8 REPORTS DIRECT TO COUNCIL**8.3 PELICAN WATERS SOUTHERN LAKES CHANGES TO INFRASTRUCTURE AGREEMENT**

File No: 2009/510022.05

The purpose of this report is to seek Council's determination of a request to vary an Infrastructure Agreement for the Pelican Waters Southern Lakes Preliminary Approval.

Figure 7 - Applicant’s proposed amended open space layout

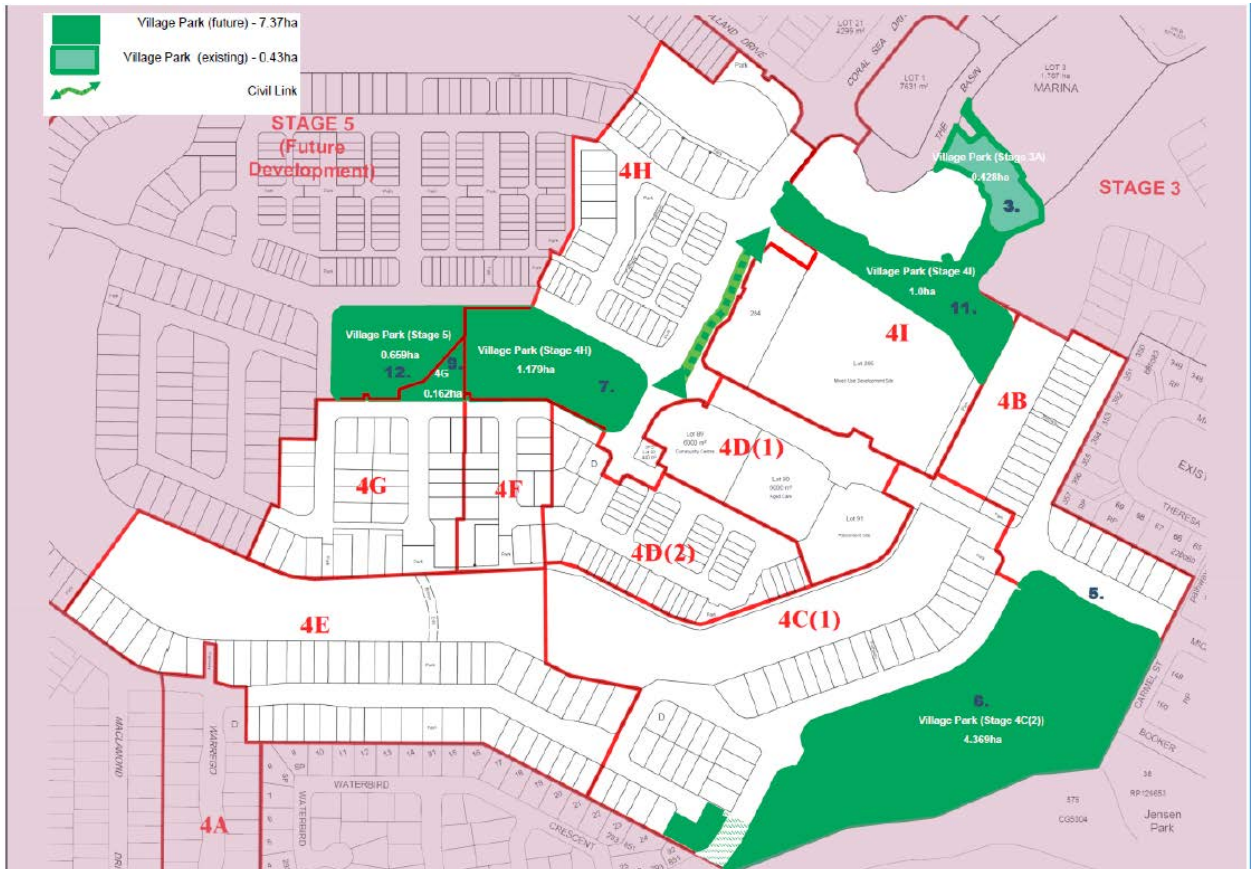
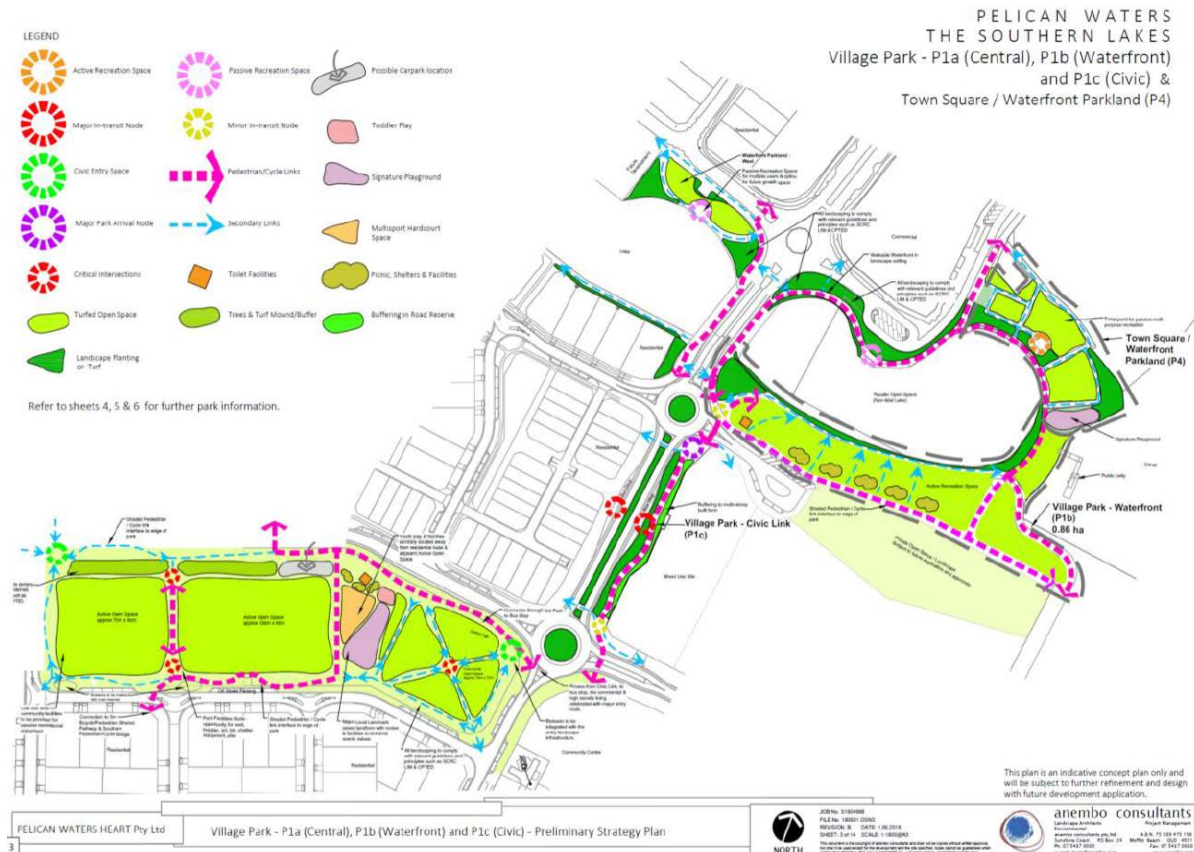
“The proposed Village Park areas comprise:

- 3.428ha of ‘Central Park’ (plus recreational lake), as required by Item 6.1.1 of the Infrastructure Agreement (3.0ha), made up of one lot (in 2 parts) as follows:
 - A 2.0 hectare central location (Village Park – Central) comprising 1.179ha in Stage 4H, 0.162ha in Stage 4G, and (contiguous) 0.659ha in future Stage 5; and
 - A 2.588 hectare recreational precinct (Village Park – Waterfront) comprising 1.428ha of parkland (1ha in Stage 4 and 0.428ha in Stage 3A) and approximately 1.16 ha of recreational lake; and
- A 4.369ha Jensen Park extension in Stages 4B and 4C. This complies with the requirement for Village Park (4.315ha) set out as item 6.1.2 of the Infrastructure Agreement.”

“The two Village Park parts will form one lot connected by a ‘civic link’ along the western side of proposed Lot 284. This road reserve has been widened to accommodate this link, featuring a 3 metre wide combined pedestrian/cycle path, seating and feature elements and planting. The civic link will also tie into the Major Transit Station required by Item 4.1.1 of the Infrastructure Agreement, and continue south to the lake, servicing both the central and waterfront components of the Village Park.”

In addition, the Environment and Sustainability Policy Branch – Open Space and Social Policy team has considered the proposed amendment to split the district open space (2ha plus 1ha) and has provided the following comments.

“The split arrangement does not meet the following policy requirements (adapted from the ELS):

- *District Recreation Park Desired Standard of service: A regular and compact shape that can accommodate the intended role and function – 2 ha in one part referred to as central park and 1.14 ha of a civic space (referred to as waterfront park) separated by a major road is not a compact shape and cannot accommodate space large enough to attract residents and visitors from the local community and surrounding suburbs whilst providing a variety of spaces, settings and facilities, opportunities for community events and celebrations as well as landscape enrichment, biodiversity or cultural conservation.*

- *Minimum width: A District Recreation Park must be 50 – 100 m wide and have 50% or 2 sides with road frontage. The waterfront park will not achieve this.*

- *Open Space Policy Positions 5.1 c Open space is flexible and adaptable to allow for diverse recreational, sporting and cultural experiences and 5.1 b Open space is protected for its appropriate function including openness – 2 ha of land in central park is not sufficient to allow such flexibility and retain large areas of openness. 1.14 ha of waterfront park will be largely a civic space with significant hardening and unable to be adapted to provide flexibility for future recreation uses.*

- *The embellishment requirements for a District Recreation Park specify that a district park can have a (singular) car park, toilet, event space, multi-purpose court. However if the proposal for 1.14 + 2 ha of waterfront and central park were to be approved, such embellishments may be duplicated resulting in significant maintenance costs for Council.”*

In summary, the officer's recommendation is to not support the proposed amended open space configuration changes given the inconsistency with the applicable open space policies as discussed above.

However, Council may elect to accept the applicant's proposal in relation to the open space configuration for the reasons put forward by the applicant above, noting the applicant is proposing to reduce the value of the infrastructure offsets so that only the delivery of the 2ha park would be eligible for receiving offsets.

Figure 13 - Proposed Drawing 5– Pedestrian/Cycle Network

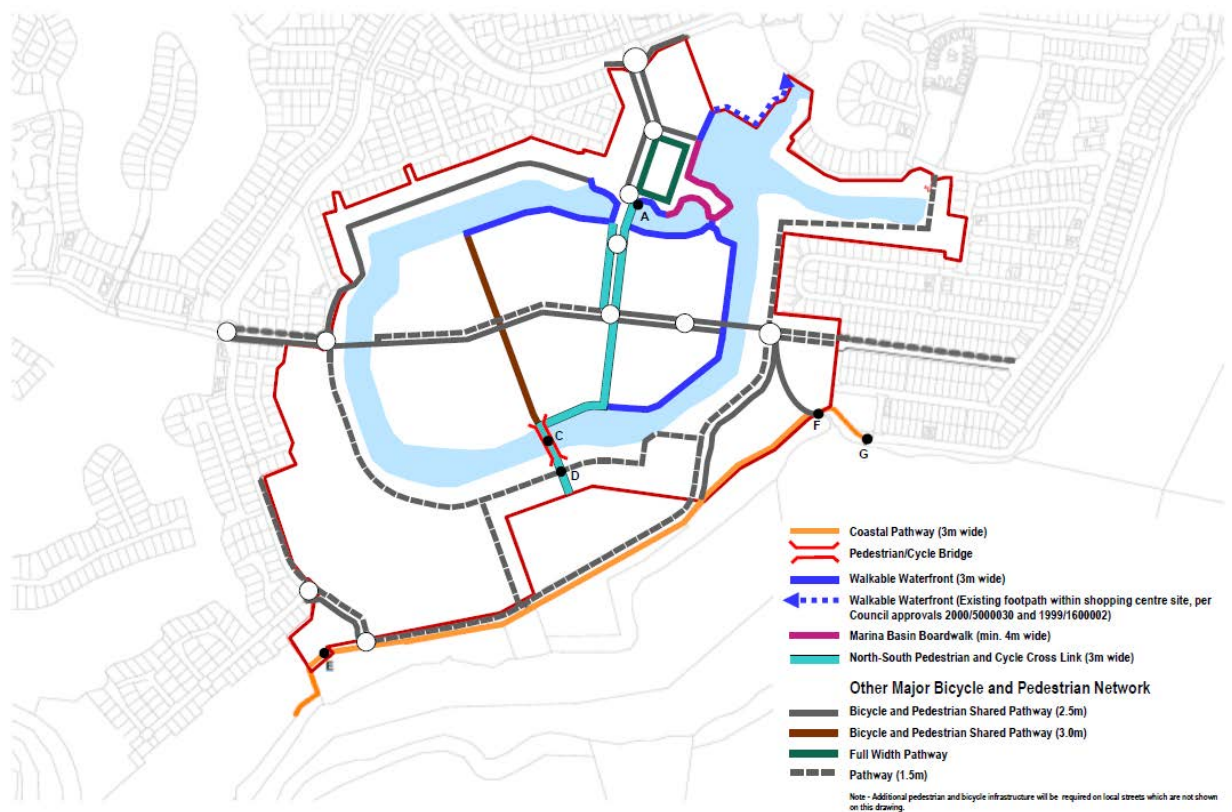
“The proposed amendment seeks to remove the requirement for the northern pedestrian/cycle bridge based on a review of demand and travel distances, the redistribution of key open space elements, the proposed rationalisation of and improvements to the bicycle and pedestrian circulation networks and the creation of an integrated movement and facilities spine through the Pelican Waters Heart precinct.”

“the northern pedestrian bridge is unwarranted from both a pedestrian network perspective and a commercial viability perspective. Further, the removal of this northern pedestrian bridge from the active transport network will not negatively impact any residents or businesses. The southern pedestrian/cycle bridge is proposed to be retained (and constructed) as it will create a useful linkage to the Coastal Path and the Bells Esplanade (former ‘Lambert’ land) areas.”

- A significant pedestrian pathway network comprising 3m wide bicycle and pedestrian shared pathways and on road cycle lanes (refer to above proposed Drawing 5), will link the northern community to the central park for the majority of the distance.

the existing northern residential community, the town centre and the southern pedestrian bridge (refer to above proposed Drawing 5).

In summary, the officer's recommendation is to support the proposal to remove the requirement to construct the northern pedestrian bridge and amend the Infrastructure Agreement accordingly for the reasons discussed above.

Figure 14 - Proposed Drawing 6 – Bridge Design Specifications

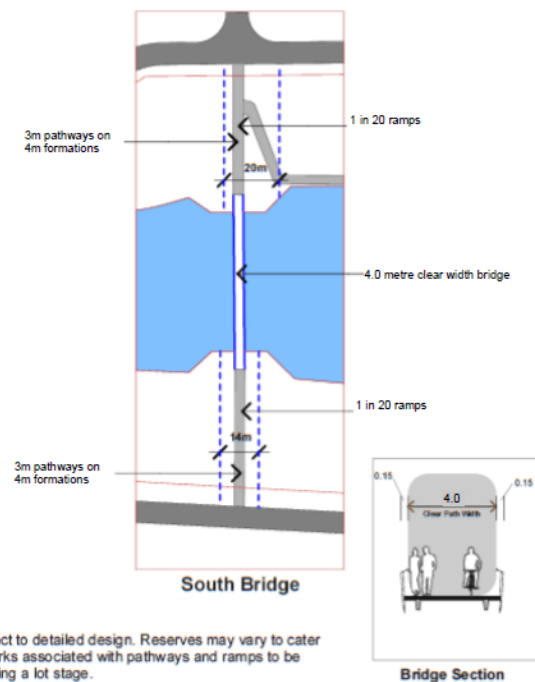
In lieu of the northern bridge the applicant is proposing a wider southern bridge (4.0m clear width) as shown in the below proposed amended Drawing 6:

- The applicant is proposing to increase the width of the southern pedestrian bridge (4.0m clear width) in lieu of constructing the northern bridge (refer to above proposed Drawing 6). This will be beneficial as the southern bridge will be used more intensely given it will provide a direct connection to the coastal path with the Central Park/Town Centre. In addition, the applicant is proposing a wider pedestrian network (3.0m) linking

Figure 16 - Comparison of Walking Distances for Northern Community

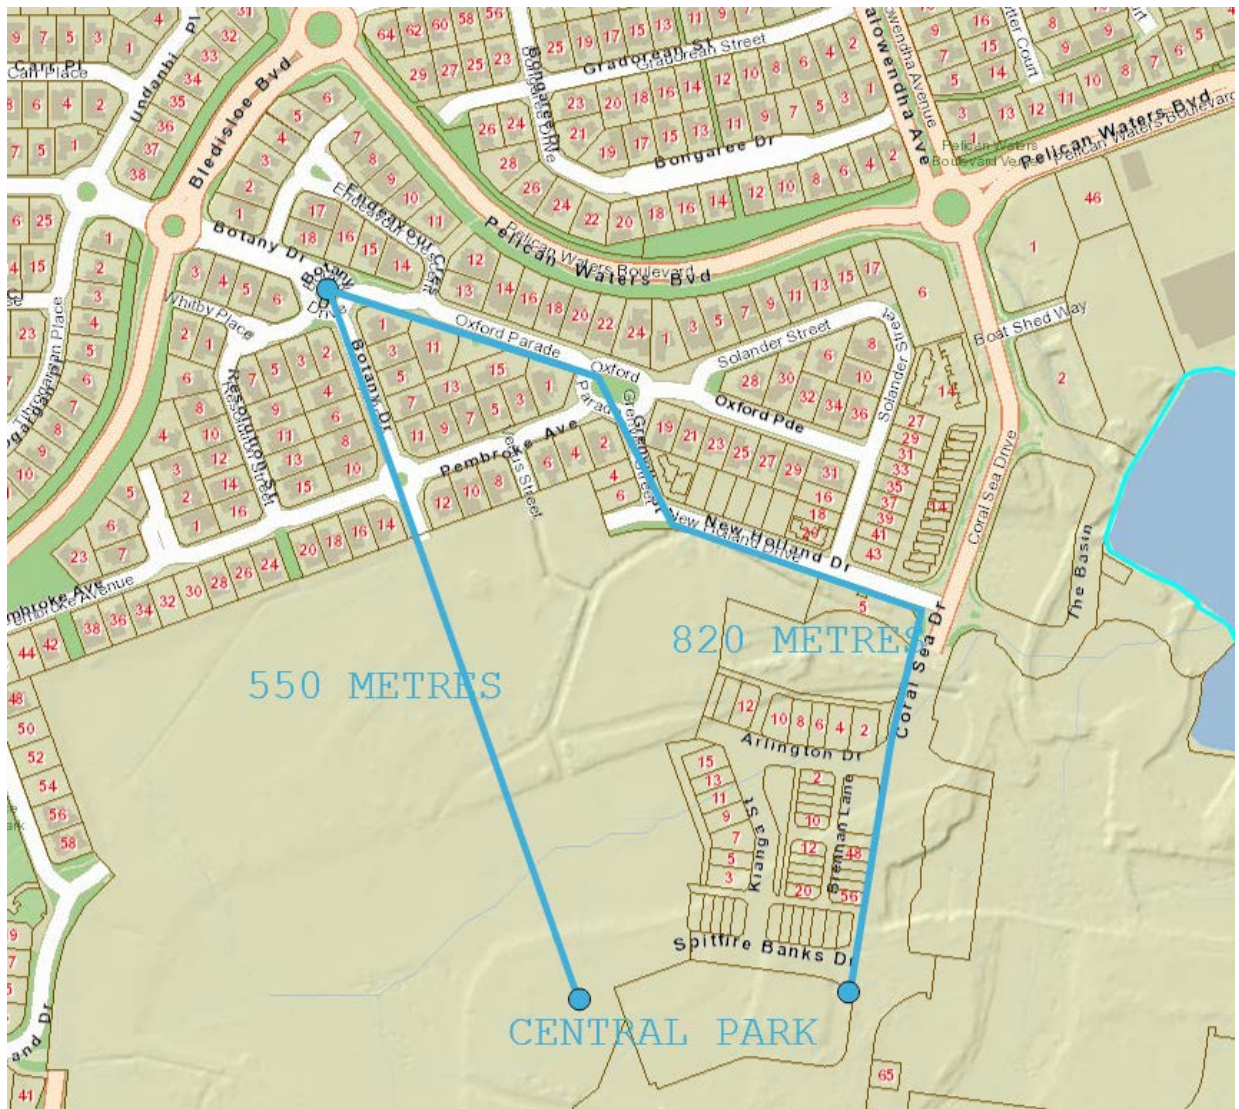
The below plan shows a comparison of walking distances from a central point within the existing northern community both with and without the northern pedestrian bridge. It demonstrates that it will be approximately 330m greater walking distance from this point if the bridge is not provided.

While removing the bridge will result in greater walking distance for the northern community to the Central Park (approximately 330m), the following reasons are considered sufficient to warrant the proposed removal:

Figure 18 - Proposed Drawing 3 – Transport Network

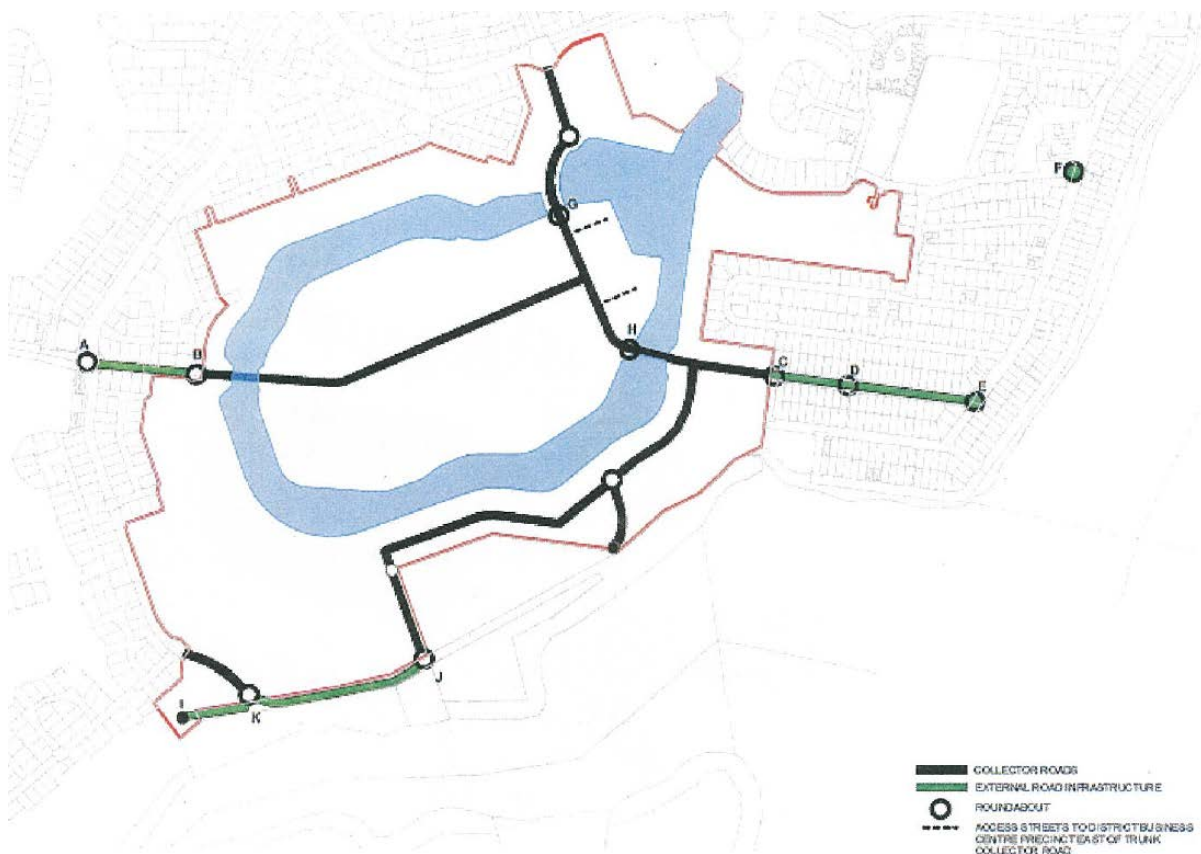
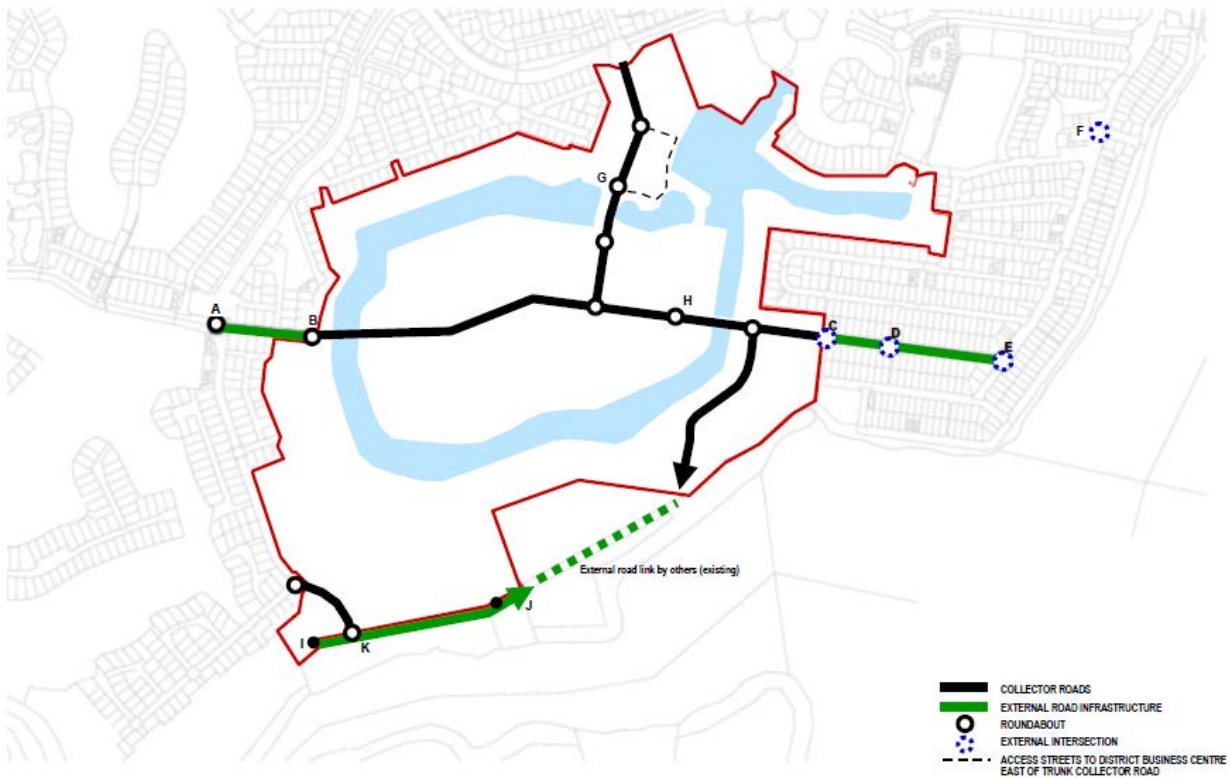
In addition to the above changes, an updated Drawing 3 has been provided as per below. Notably point F has moved slightly north to the Anning Ave/ Roy Street intersection.

In addition, Council's Traffic Engineer has no objection to approving the new roundabout location (point F on Drawing 7), moving it from the current Verdon Street / Anning Avenue intersection to the Roy Street / Anning Avenue intersection. This new map will have implications for item 3.1.7 of Schedule 2 of the Infrastructure Agreement, which refers to point F on Drawing 7 (but it is not necessary to make any changes to the wording of this item as it is only the location of the works that are changing).

In summary, the officer's recommendation is to support the amendment to item 3.1.6 as per the wording proposed by the applicant and changes to Drawing 7 as discussed above.
